Agenda Item # 2 SUB-003027-2024

1859 Toulmin Avenue Subdivision

- Subdivision approval to create one (1) legal lot of record from one (1) metes-and-bounds parcel.

DETAIL SITE PLAN

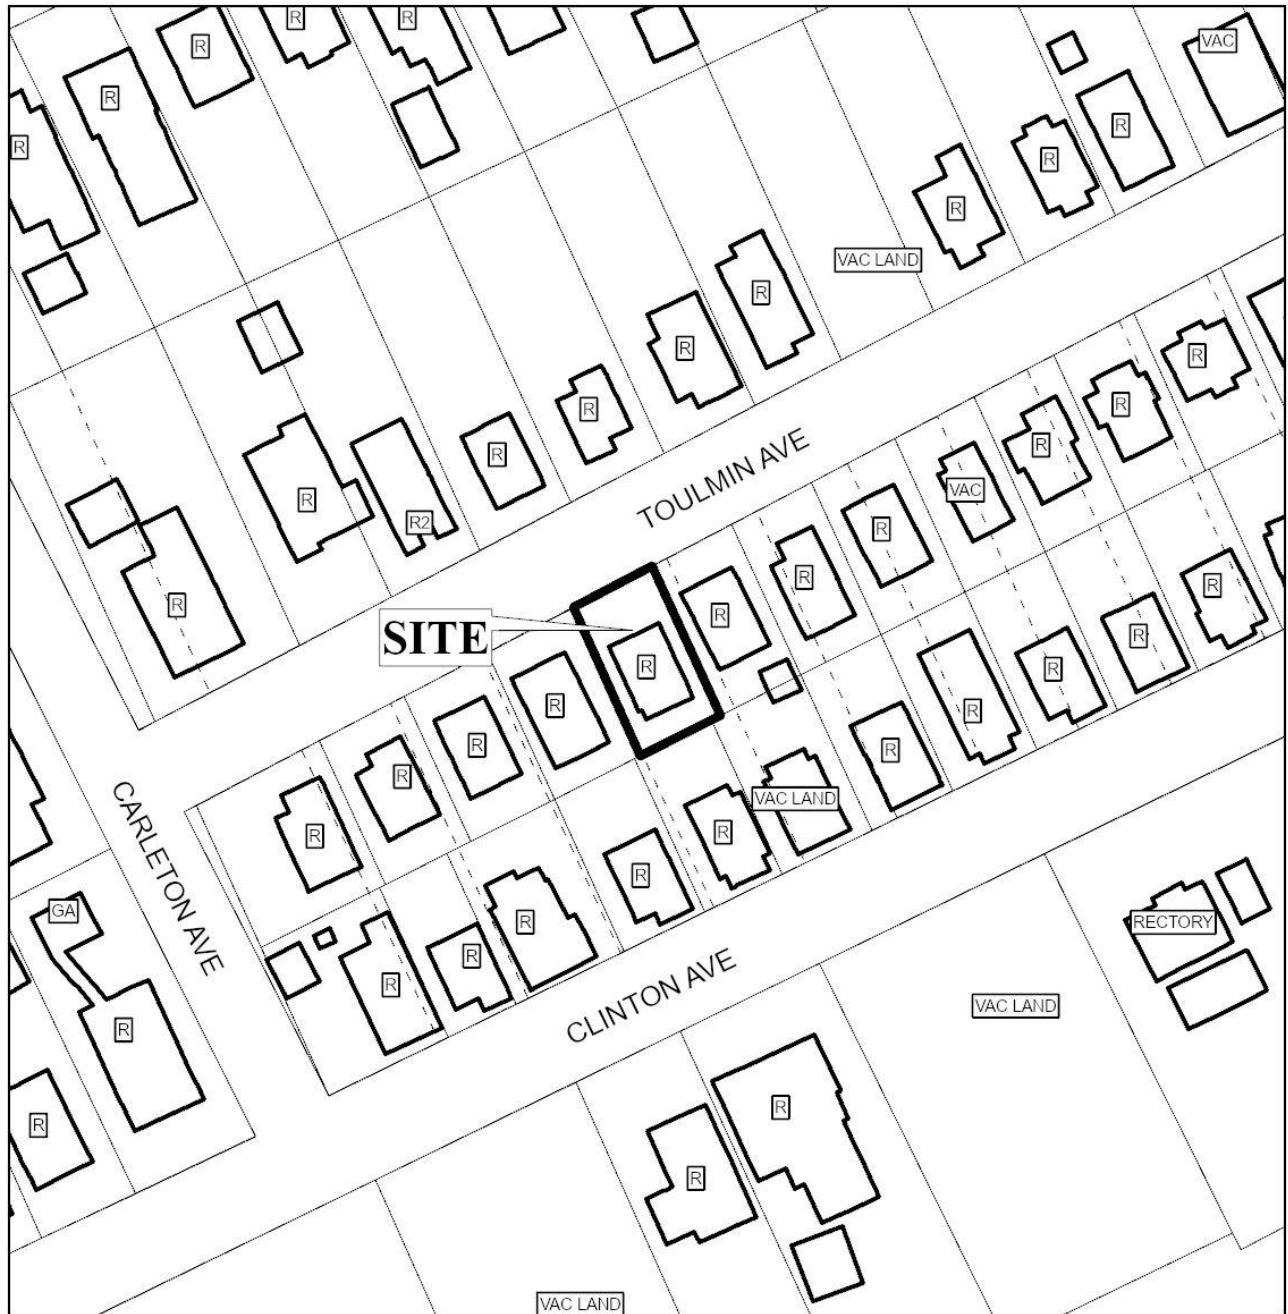
The site has frontage on Toulmin Avenue, a minor street with curb and gutter requiring a 50-foot right-of-way width. The survey depicts a 50-foot right-of-way width at this location, making additional dedication unnecessary.

The lot, as proposed, does not meet the minimum size requirements for lots served by public water and sanitary sewer in an R-1 urban district. Additionally, the survey is not appropriately labeled with the lot size in both square feet and acres. If approved, a waiver of Section 6.C.2(a)(1) of the Subdivision Regulations will be necessary for the reduced lot size. Additionally, the Final Plat should be revised to include the lot size in both square feet and acres; or placement of a table on the Final Plat with the same information.

The lot does not meet the minimum 60-foot width requirement of Section 6.C.2(b)(3) for residential lots located within the urban sub-district. If approved, a waiver of Section 6.C.2(b)(3) of the Subdivision Regulations will be necessary.

The survey illustrates a five (5)-foot front yard setback along Toulmin Avenue, in compliance with Section 64-2-5.E. of the Unified Development Code (UDC) for lots in the R-1 urban district. If approved, this information should be retained on the Final Plat.

Five (5)-foot side yard setbacks and a five (5)-foot rear yard setback are illustrated along side and rear property lines, which is not required by the Subdivision Regulations. As such, removal of the side and rear setbacks from the Final Plat should be required, if approved.

1. Retention of the right-of-way along Toulmin Avenue, as depicted on the survey;
2. Revision of the Final Plat to include the lot size in both square feet and acres, or placement of a table on the Final Plat with the same information;
3. Retention on the Final Plat of the five (5)-foot minimum front yard setback along Toulmin Avenue;
4. Removal of the side and rear yard setback lines from the Final Plat;
5. Compliance with all Engineering comments noted in this staff report;
6. Placement of a note on the Final Plat stating the Traffic Engineering comments noted in this staff report;
7. Compliance with all Urban Forestry comments noted in this staff report; and
8. Compliance with all Fire Department comments noted in this staff report.
